ZONING CHANGE REVIEW SHEET

CASE: C814-2017-0001 – 425 W. Riverside PUD

ADDRESS: 425 W. Riverside Drive

ZONING FROM: CS-1-V-NP **TO:** PUD-NP

EXHIBIT F - LAND USE PLAN-OPEN SPACE

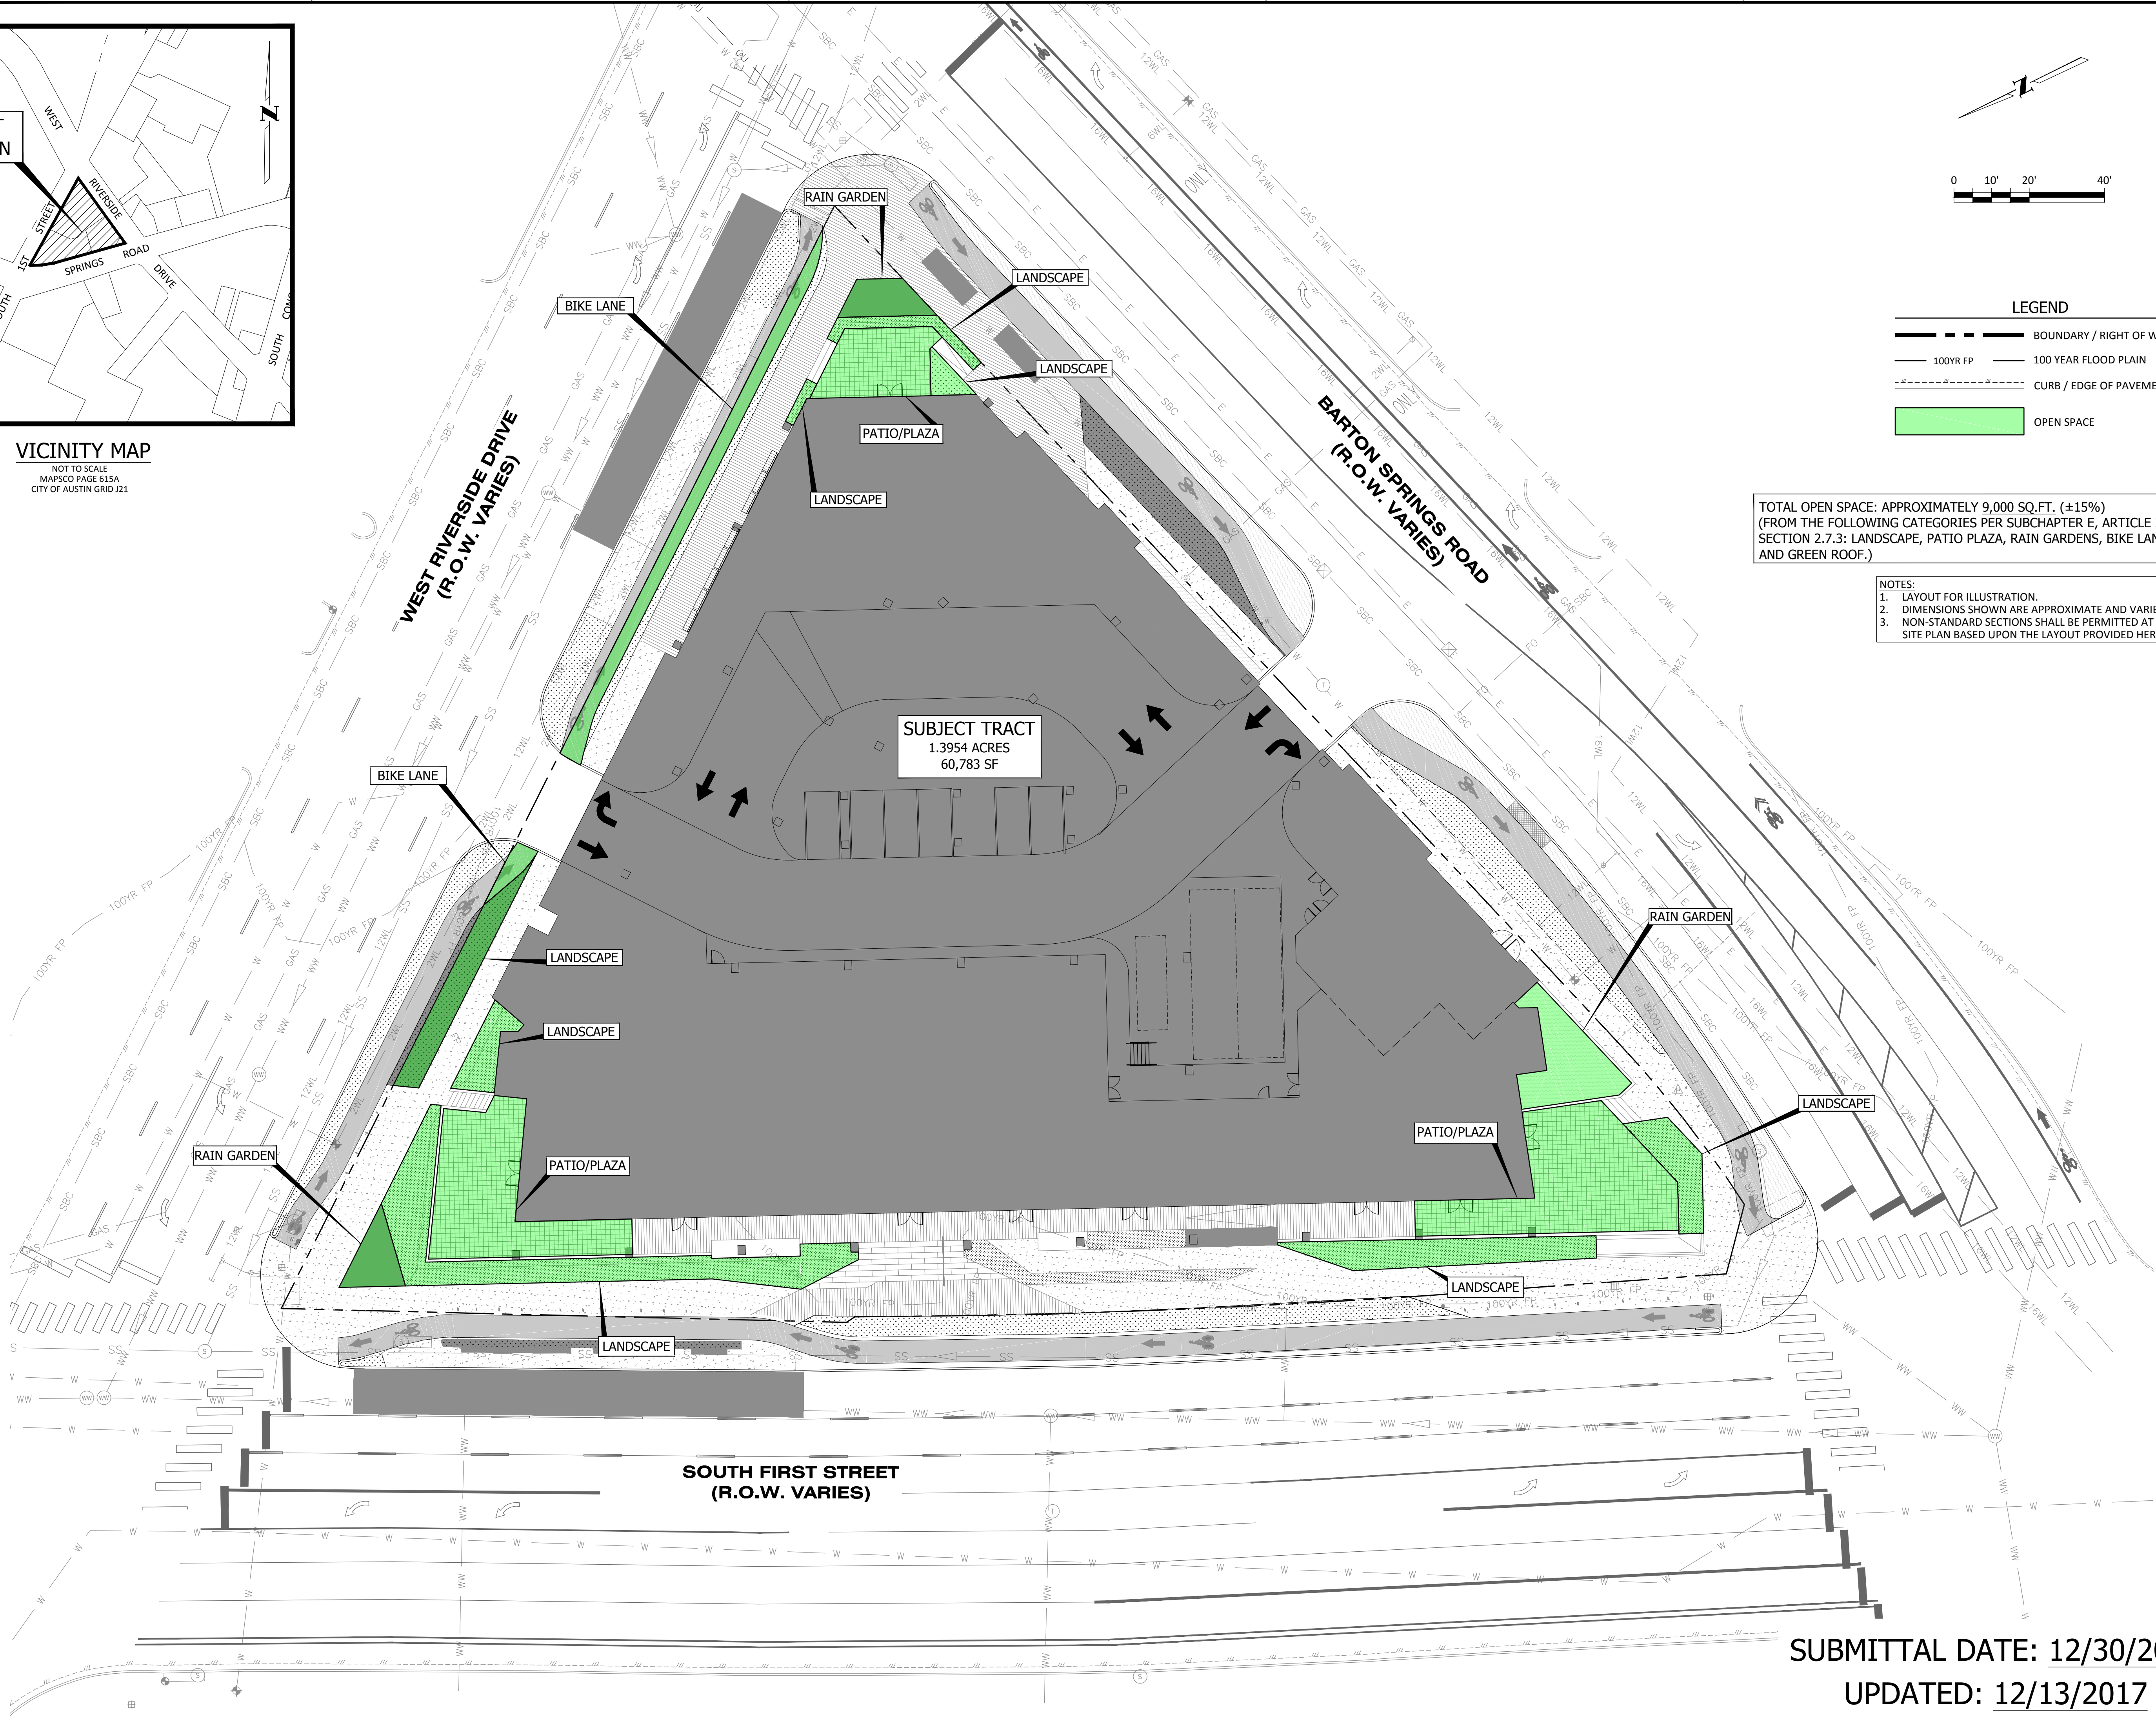
U3: The proposed Open Spaces A, B, C, and D (green roof) are acceptable, as is the minimum commitment of 15% of the site. However, please prepare an open space exhibit that can be included with the PUD ordinance. (Something like the submitted exhibit can be used, but it currently says “for informational purposes only – Update 2”). This comment can be cleared informally.
